City of Phoenix PLANNING AND DEVELOPMENT DEPARTMENT

Staff Report Z-78-18-2 January 4, 2019

Proposed Use: Multifamily (townhomes)

Location: Approximately 100 feet north of the northwest corner of 7th Avenue and Anderson Drive

Source: Kenyon Architectural Studio

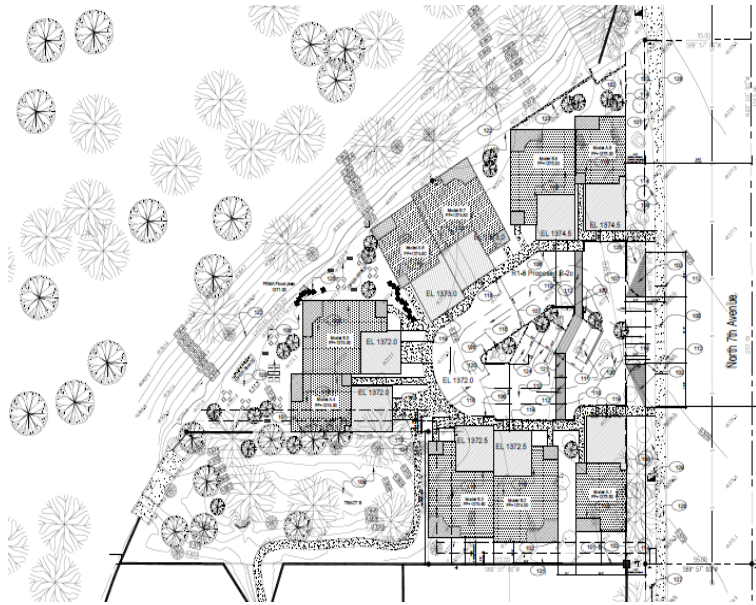
4. The conceptual site plan depicts nine multifamily residential townhome units along a private access way with one-way access through the site from 7th Avenue.

The site plan shows approximately 6.77% common area open space, including open space areas adjacent to the Cave Creek Wash. The developer is not providing a connection to the wash due to the steep slope. To ensure that the development does not exceed nine units, staff is recommending Stipulation No. 1 to limit the number of units. The same developer owns the single-family development directly to the south. The sites will share a drainage retention area. The multifamily proposal and single-family site to the south will also share the same homeowner's association. The two sites will function as one community.

1. The development shall not exceed 9 units.
2. Perimeter fences or walls adjacent to the wash shall be view fencing. Any solid portion of the wall shall not exceed 4-feet in height, as approved by the Planning and Development Department.

Source: Kenyon Architectural Studio

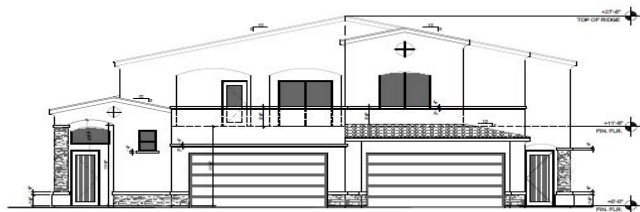
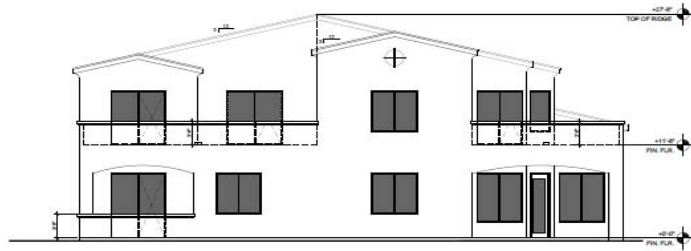
5. The elevations depict two-story multifamily residential units with enclosed entryways and garages along their front elevations. Staff is recommending a stipulation that all units shall have covered porches, which face the front, and are a minimum of 60 square feet in area with a depth of at least six feet. This is addressed in Stipulation No. 4. Front porches help to encourage activity in the

front of the homes, provide variation in building elevations, and subsequently make the streets more inviting and safer places to walk. Further, in order to provide privacy to the single-family residence to the south, staff is recommending a stipulation restricting balconies along the southern property line. This is addressed in Stipulation No. 5.

4. All dwelling units shall have covered porches, which face the front, and are a minimum of 60 square feet in area with a depth of at least 6 feet, as approved by the Planning and Development Department.

5. There shall be no second floor balconies adjacent to the southern property boundary, as approved by the Planning and Development Department.
6. The right-of-way shall be dedicated and a bus bay (per City of Phoenix Standard Detail #P1260) constructed at the intersection of 7th Avenue and project driveway (per City of Phoenix Standard Detail P1258), as approved by the Planning and Development Department.
